APPLICANT EXHIBIT LIST

HEARING DATE: Thursday, July 18, 2019, at 9:00 am. **FILE NUMBER:** HEX2019-01 1 (PDS File No.: LU18-0301)

HEARING EXAMINER FILE NAME: Tacoma Life Properties, LLC (PDS File Name: Tacoma Behavioral Hospl; al)

Consolidated Response to Public/Agency Comments

TACOMA BEHAVIORAL HOSPITAL 2019 SITE PLAN

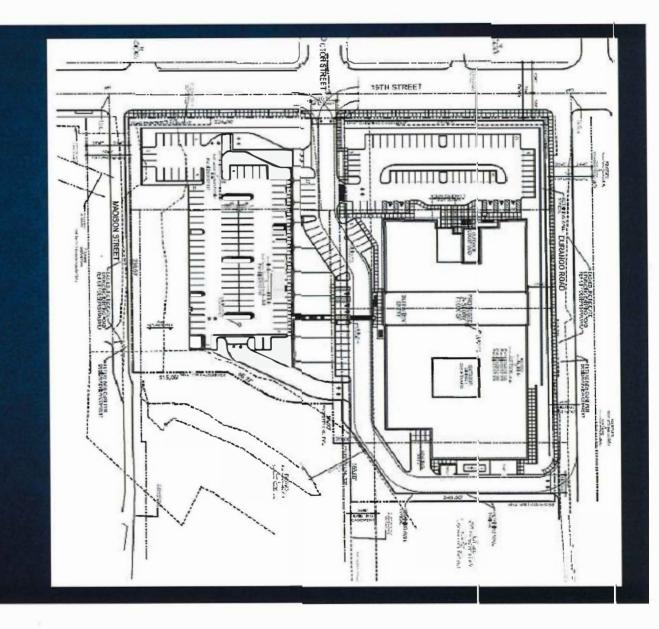
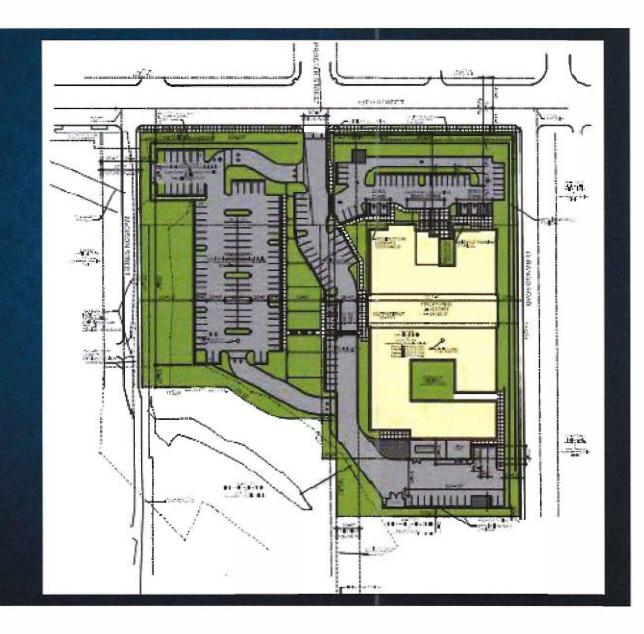
6. The application for locating onsite parking between the proposed building and South 19th Street results in adverse and significant impacts to ingress and egress, along with associated impacts to pedestrian and vehicular traffic. The site plan includes 193 parking stalls. Contrary to the narratives provided by the Applicant, allotment of 193 parking stalls neither renders quiet use of the parking area with traffic entering, parking, and leaving the parking area nor does the volume of parking stalls generate little traffic. Rather, 193 parking stalls generate a substantial amount of traffic not properly accounted for or mitigated by the Applicant. These impacts are intensified as the proposed use is a 24-hour facility. For the Applicant to suggest "the activity levels at any given time of the day would be comparable with levels typically associated with a residential use" is absurd based on the volume of parking stalls alone. (See CUP Narrative, page 5 provided by the Applicant in support of the CUP application).

8. The Applicant's proposed site plan places the building along approximately 80% of Durango Street frontage and 0% on South 19th Street. The Applicant's justification for this placement is merely that access should be along the arterial of 19th Street and that site grading and power lines prohibit the placement of a single building along 19th Street. The Applicant's justification is flawed and requires scrutiny by the City. In contradiction to the justification as to where to place the building, the Applicant, for the parking and access deviation, uses the residential character of Durango Street as the reason no rear access should exist. It makes little sense that because the Applicant is not willing to have multiple buildings straddle the access at the South 19th Street/Proctor intersection,

In response to staff review, the Applicant's proposal has since been revised to eliminate the access originally proposed for Durango Street; complying with the policy goal intended to discourage projects from directing commercial traffic onto residential streets. Pedestrian circulation on South 19th Street and Durango Street will not be adversely affected; onsite pedestrian pathways will direct pedestrians to the building's entry or to adjacent rights-of-way.

The proposed site plan offers the best balance between the site's constraints, Tacoma's code requirements and the hospital's needs. In devising this site plan, the Applicant reviewed a previously approved project (Madison Park, 2005) with 3 buildings designed for medical and dental offices and some commercial uses. This project also provided for multiple stories – with parking located beneath offices. The volume of parking provided there (303 stalls) and the location of buildings onsite suggested to the Applicant a better design was needed to address Tacoma's code and respond to the site's topography and areas that are unbuildable due to immovable utility transition lines that cut through the property.

The current site plan addresses a type of facility which requires a single structure, rather than dispersing the use across multiple buildings and requires/provides far less parking (193 stalls) as a result. Any placement of a single building immediately adjacent to the South 19th Street frontage would have been impossible due to immovable utility lines and would have significantly increased grading and site disturbance. With more than 30' of elevation change along South 19th Street, there was no way to place the building in this orientation and to satisfy the code requirements along the entire frontage. Limiting the scale by placing the hospital in the proposed orientation, perpendicular to South 19th Street and the grade change, was a preferred option – by both the Applicant and Tacoma staff.
